**Town of Rotterdam
Planning Commission
March 3, 2026**

DPW Comments
March 3, 2026

Plan Comments

5932A-02252026

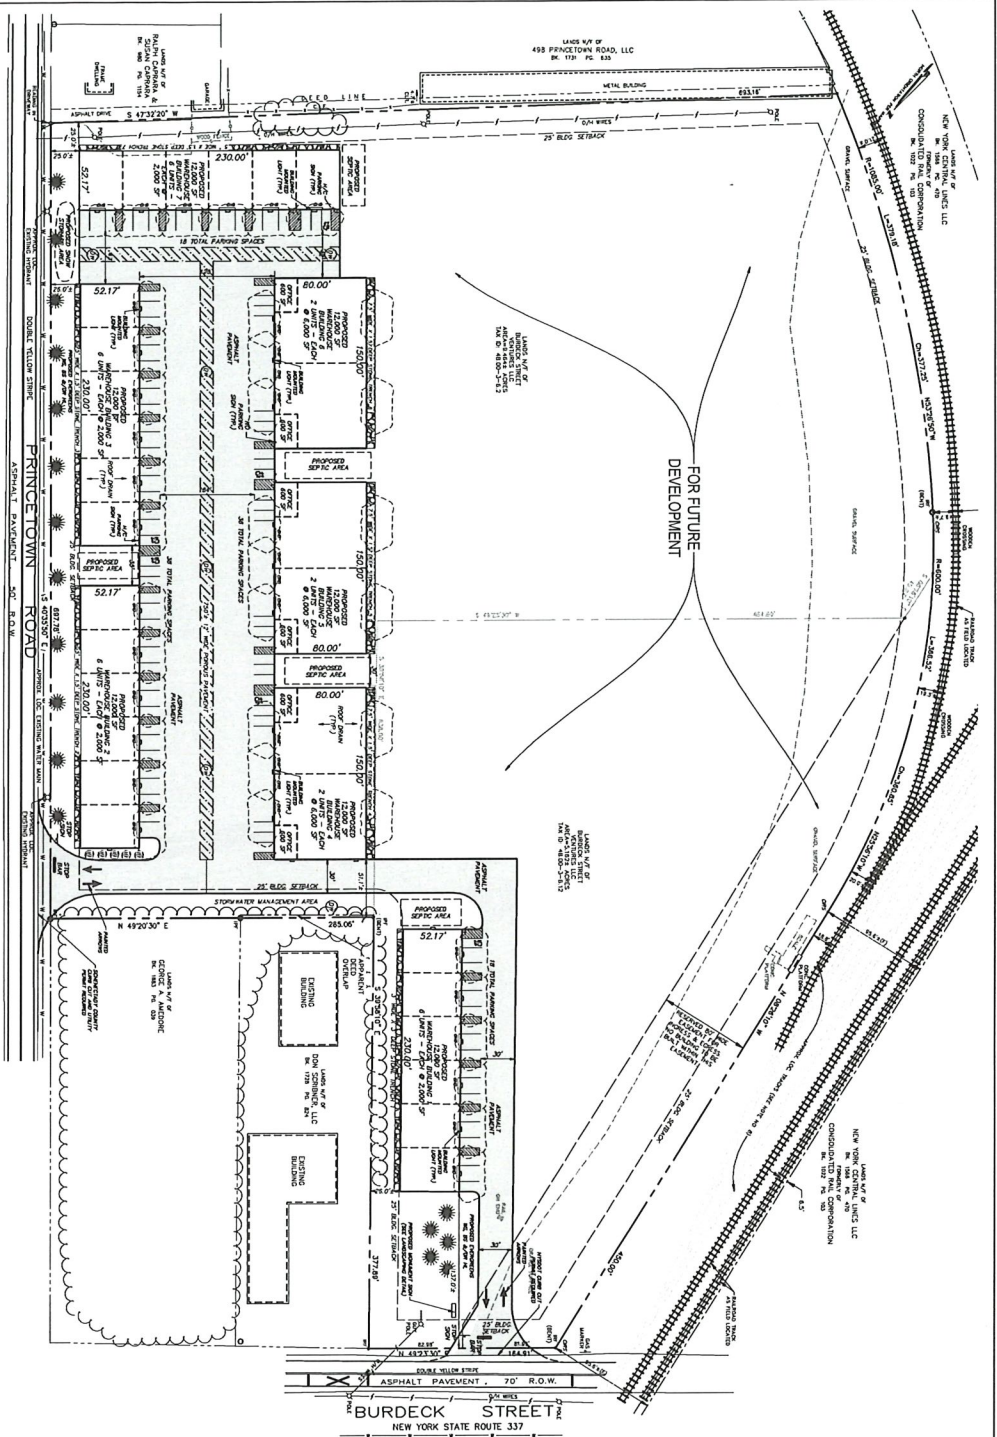
9. Change note on Sheet 1: "One water meter shall be installed on the service connection. Final type and location to be approved by DPW."
10. Change note on Sheet 1: "Owner/applicant shall install Knox Box for emergency personnel. Check with Fire District #6 for specifications."

11. Change note on Sheet 1: "Building design shall be in substantial conformance to the proposed Exterior Elevations presented to the Planning Commission on March 3, 2026."

12. Add note to Sheet 1: "Landscaping shall be maintained in perpetuity and dead/dying plant materials shall be replace in-kind."
13. Final approval is contingent upon the applicant receiving permits (site development and building) from the DPW Building Inspector.

**THIS PLAN TO BE UTILIZED
FOR SITE LAYOUT PURPOSES
ONLY**

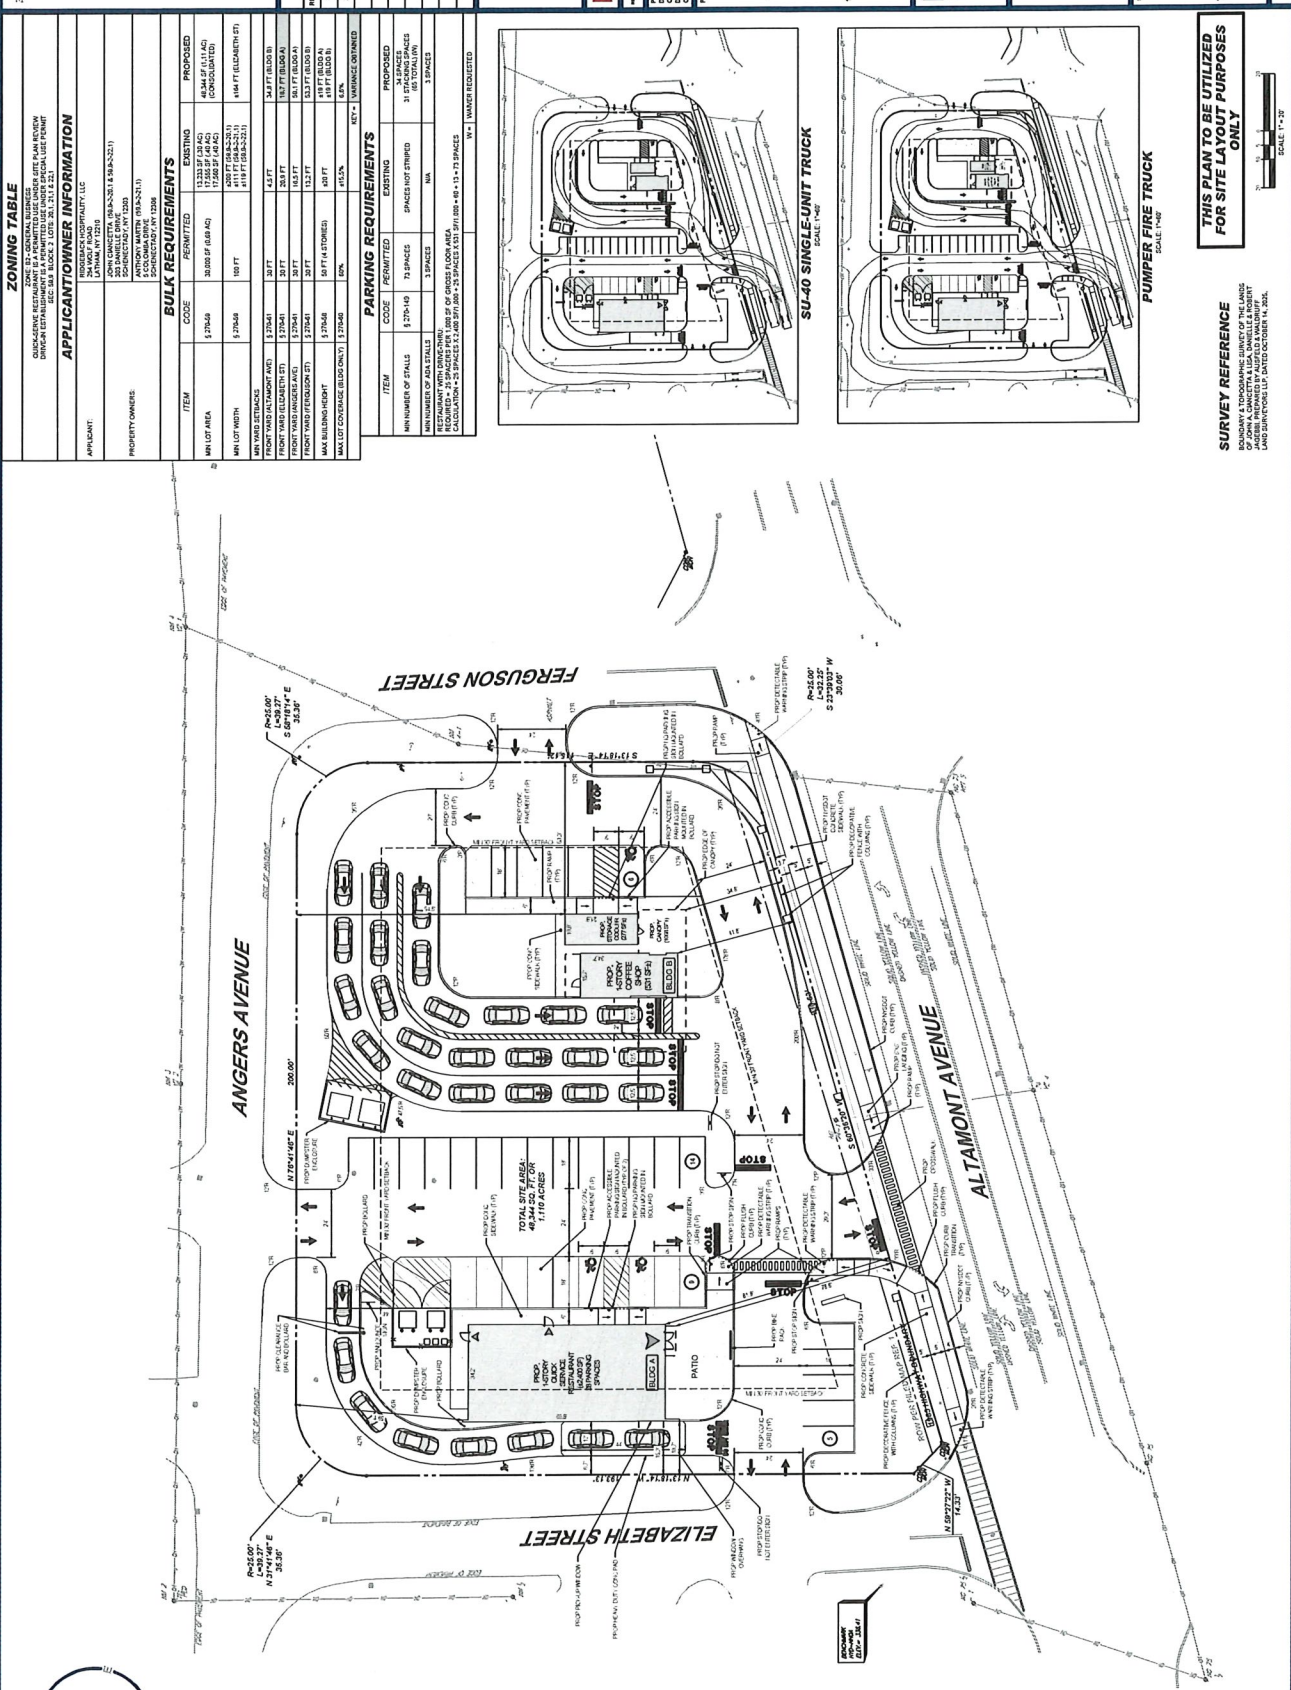
1. Applicant is to include a sidewalk along Elizabeth Street as part of the site development. Applicant should consider the extension of this sidewalk along the north side of Angers Ave. to connect with the curb and walk at the east side of the Market 32 property (see plan 1). This would provide a pedestrian connection to the site and Altamont Avenue from the bus stop and sidewalk at Market 32. The section along Angers Ave. (approximately 156'± in length) would also require curb to match the tie in condition at the west end. The walk would be adjacent to the curb along Angers. A sidewalk/crosswalk pedestrian connection from the Elizabeth Street sidewalk to the Chipotle patio could be made in front of the stop bar at the Chipotle pick up window (see plan 1).

2. Applicant is to install an ornamental fence with stone piers similar to or matching the design of the fencing installed at the Chase Bank, located immediately to the west of the site, to provide design consistency within the Altamont Ave. corridor. The fence should have a return section along Furguson Street (see plan drawing 2 notes at the end of this pdf).

15. The grade break of the sidewalk curb ramp on the west side of the proposed driveway at Altamont Avenue should be perpendicular to the direction of pedestrian travel (see plan 1). Perpendicular grade breaks for the all curb ramps should be located as close to the curb line intersection as possible.

23. For the minor site driveways on Elizabeth, Ferguson, and Angers, it is unclear what standard is being applied to the driveway radii. The radii at Elizabeth St. are listed as 12' whereas the other two streets are 10'. There are many turns that are part of the internal site circulation that also have very small radii. Radii will need to be increased at the locations indicated in green on the plan. The current radii illustrated at many of these locations, where right turns occur, will require cars to move into the oncoming traffic lane in order to negotiate the turn. Review these radii with vehicle tracking software to ensure that a passenger car can navigate all turns without encroachment into the adjacent lane (both internally to the site and on the perimeter roadways). A fifteen radius would be preferred, with a minimum radius of 12' utilized so that vehicles can negotiate the turns and remain in the correct traffic lane.

Comment acknowledged. We are proposing new sidewalks along Altamont Avenue and internally in the site to provide pedestrian access. No other off-site sidewalks are proposed at this time.

The site plan has been revised to show ornamental fence with stone piers along the Altamont Avenue frontage, consistent with other commercial businesses along the Altamont Ave corridor.

Comment acknowledged, the site plan has been revised so that the sidewalk curb ramps are perpendicular to the direction of pedestrian travel.

The site driveway radii have been revised to show a minimum of 12' radius.

Date 02/10/2026	Sheet C101	SITE PLAN	
		Title	
		Scale 1"=40'	Job# 26002

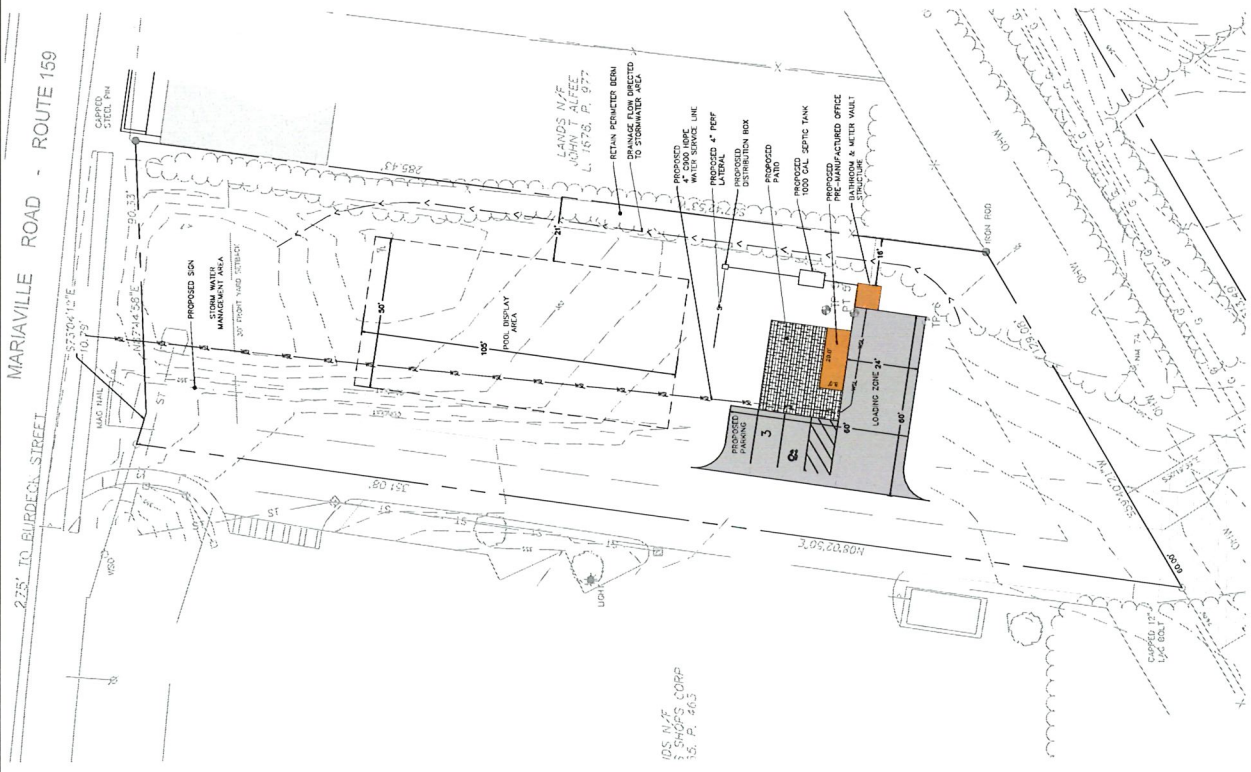
3. **Concord Pools & Spas (Lessee) - 635 Mariaville Road.** Sketch Site Plan Review to operate a sales facility for pools and spas and a commercial water tank truck delivery service for use in filling in-ground swimming pools on a ± 0.72 -acre parcel. Engineer: Empire Engineering, PLLC.
1. Applicant should address safety. Pool display area could be an attractive nuisance especially given its location next to Stewarts.
 2. Is the proposed trailer permanent or seasonal?
 3. Site Plan should be amended and operations regarding the filling of water tankers should be better detailed. What is the size of the tanker? Is it being stored on-site?
 4. The resale of Town water for commercial purposes will need to be coordinated with the Town Board.
 5. Impacts to stormwater onsite will need to be better defined.

DPW Comments May 20, 2025

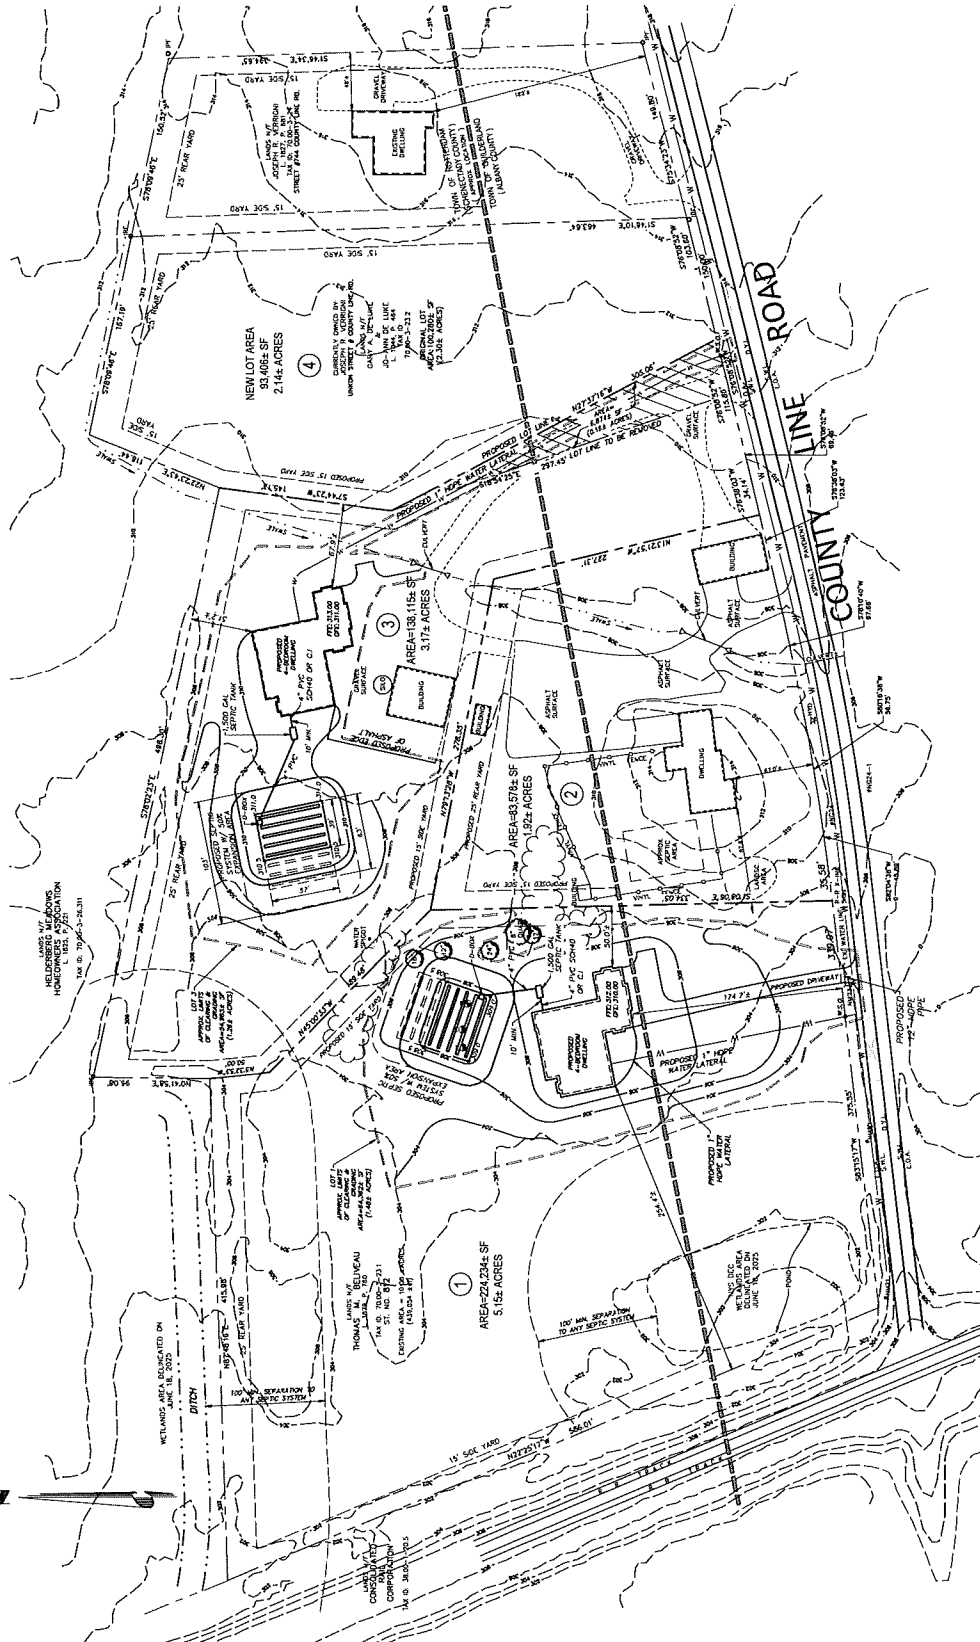
1. Address DPW comments from May 20, 2025, provide details of wetland delineation, and provide associated reports and paperwork to the Town for review.

3. Access is proposed to County Line Road in the Town of Guilderland. Applicant should apply for permits and coordinate with Guilderland. Provide all correspondence to DPW.

5. Remove the labeling for Lot #4 (lands N/F of Verrigni) and replace with “Remaining Lands.”

SITE PLAN
PROPOSED LIQUOR STORE
STREET No. 2553 HAMBURG STREET (N.Y.S. RT. 146)

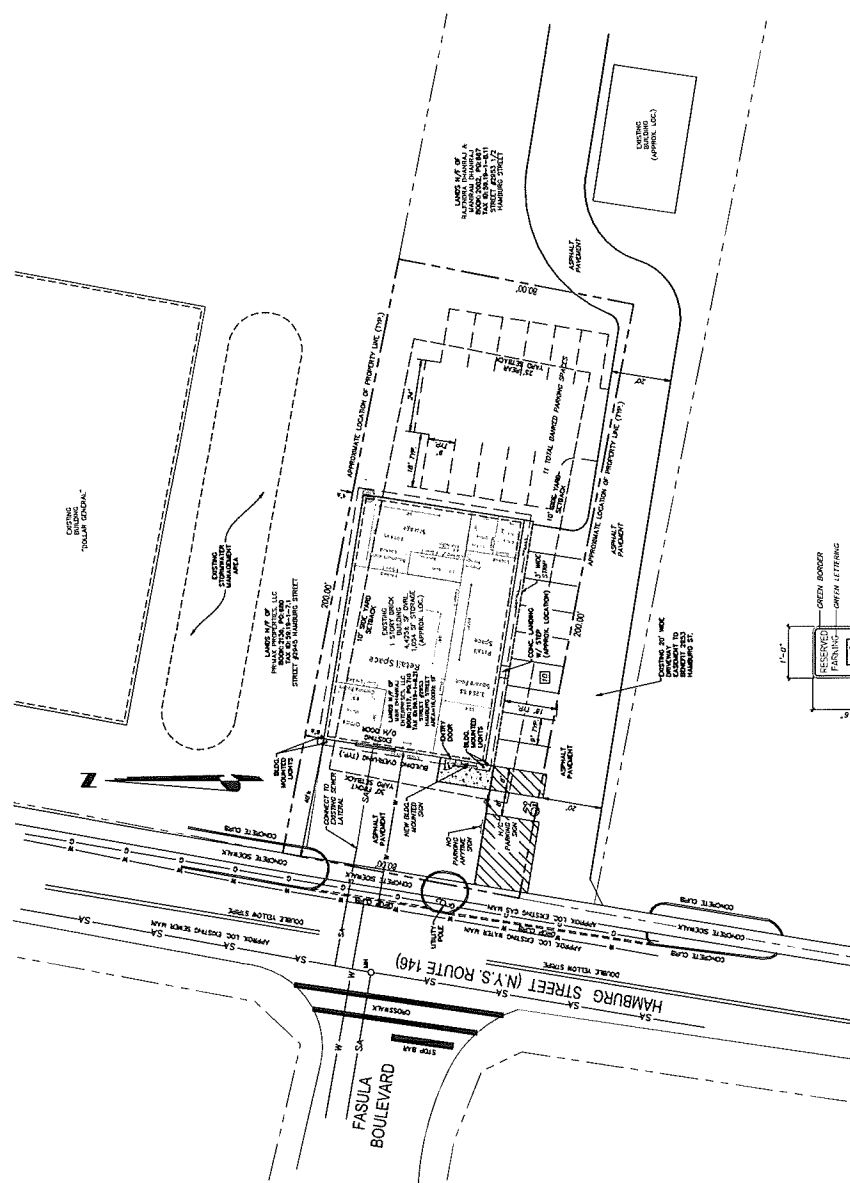
1. Building will need to be connected to sanitary sewer prior to the issuance of a certificate of occupancy.
2. Provide easement for parking and ingress/egress between properties.

3. Show improvements and utility locations for house located at 2953 ½ Hamburg Street. Existing residence should also be connected to sanitary sewer at this time.

4. Area in front of building needs improvement. Asphalt should be removed and front of building replaced with grass and landscaping. Overhead door should be sealed and front façade & entryway upgraded. Provide proposed elevations.

6. Parking is deficient. Applicant should consider adding the proposed 5 spaces along the eastern side of the building now for employees and overflow.
7. Concrete sidewalk should be added to the plan connecting the Hamburg Street sidewalk to the front door.

8. Planning Commission should consider requiring the applicant to install decorative fencing and bollards to match the new Dollar General fencing that was recently installed. Existing curb cut will need to be addressed.
